# UNITED STATES PATENT AND TRADEMARK OFFICE

## Office Action Summary

10/605,619

GARTNER, PERRY

Fig 1

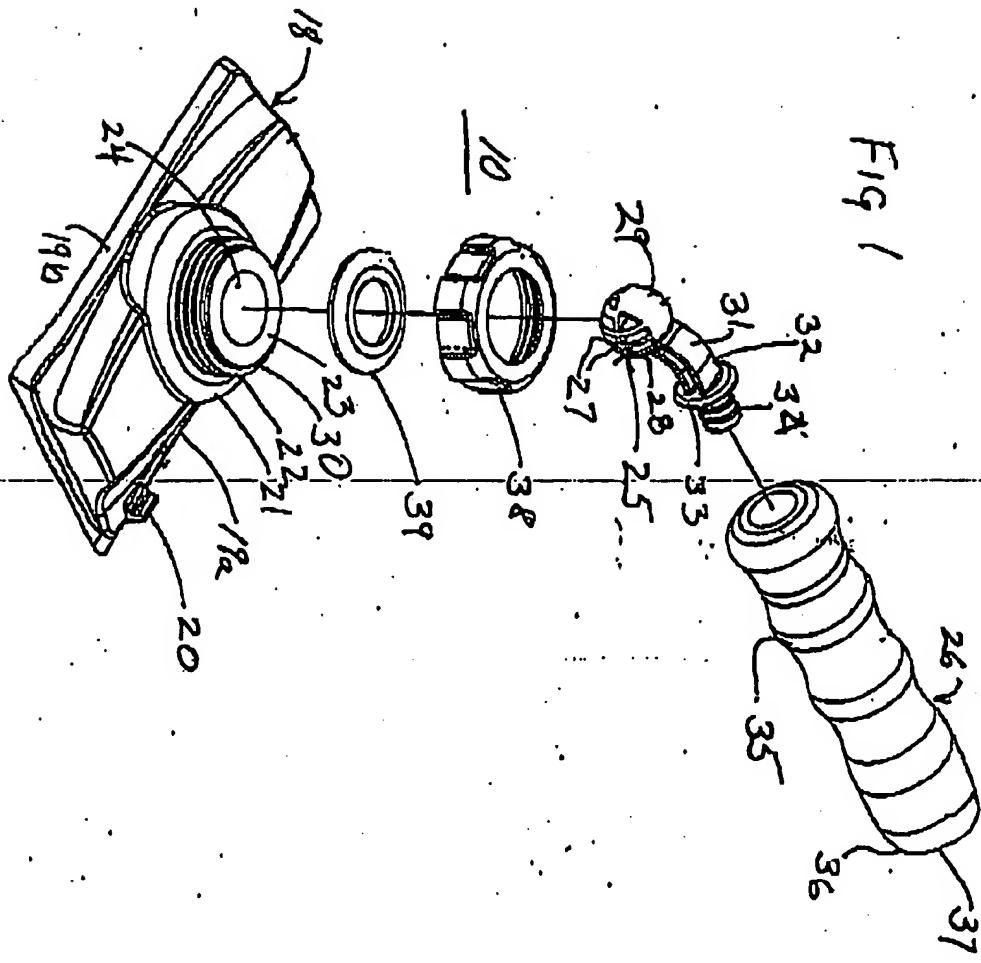
Claim 1, line 6, the recitation of "a solid handle portion having a ball at one end" makes the scope of the claims vague and indefinite since it is not exactly clear what Applicant is intending this "solid handle portion" to be. For example, viewing Fig. 1, element 28 is referred to in the specification as a **solid** base and element 29 is referred to as a **solid** portion. The claim language is confusing because it has never been disclosed that handle 26 is solid since handle 26 includes an internally threaded recess 37 as shown in Fig. 1 (which would be hollow). The handle portion 26 cannot really be considered **solid** if there is an internally threaded recess 37 at one end (Fig. 1).

Clarification is respectfully requested. **The same objection holds for claim 11, line 6, with respect to "a solid handle portion".**

A similar objection also arises in claim 4 since claim 4 recites “the ball at **one end of the handle portion** comprises a **ball integrally mounted to the solid handle portion**” (emphasis added). So, is the “solid handle portion” of claim 1 and claim 4 referring to simply the “solid base 28” (see Fig. 1)? Therefore, it is unclear what the “solid handle portion” is referring to.
